AN timeout and fast restart mechanism

Adee Ran, Cisco

Comments against D1.4

Table 119-2a--AN_LINK.indication(link_status) generation

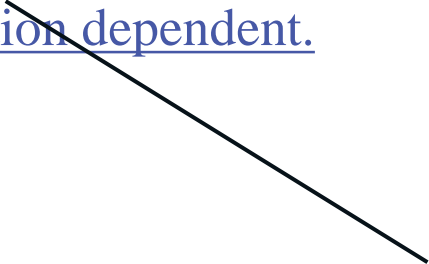
The PCS shall support the AN_LINK.indication(link_status) primitive (see 73.9). The parameter link_status shall take ~~the value FAIL when PCS_status=false and the value OK when PCS_status=true~~ one of the values FAIL, IN_PROGRESS, or OK, according to Table 119-2a.

reset + restart_lock	align_status	use_in_progress	link_status
True	Don't care	Don't care	FAIL
False	False	False	FAIL
		True	IN_PROGRESS
	True	Don't care	OK

Figure 178B–8—Training control state diagram

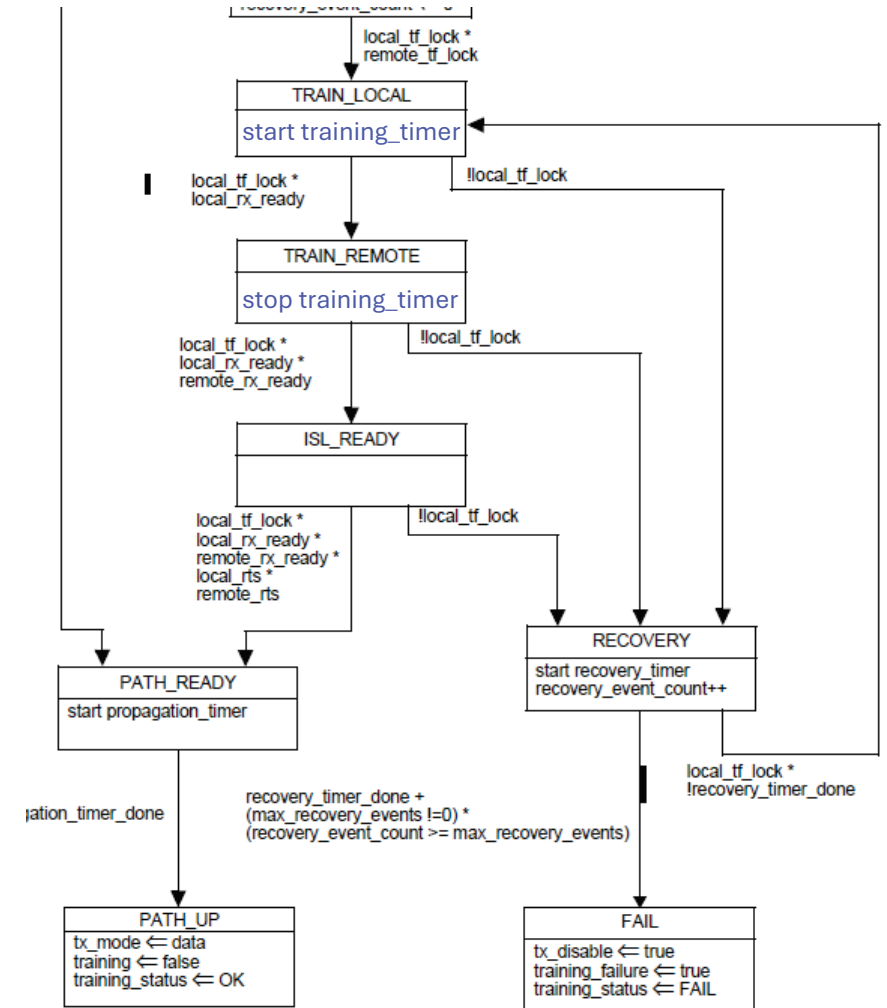
There may be a desire to limit the time consumed by the adaptation part of ILT. This can be done by adding a timer that would be accessible by management. Since a local device does not control the timing of the link partner, the timer should be active only during the TRAIN_LOCAL state. The timer period should be set by the invoking clause, and should be a configurable by management, with perhaps a recommendation in the standard.

Modify Figure 178B-8, adding a timer, as follows:
In the Train Local state, add "start training_timer".
In the Train Remote state, add "stop training_timer".

`training_timer`

This timer is started when the training control state diagram on a lane enters the TRAIN_LOCAL state (see Figure 178B–8). The terminal count of this timer is controlled by the management variable `mr_training_timer_duration`. The effect of expiration of this timer is implementation dependent.
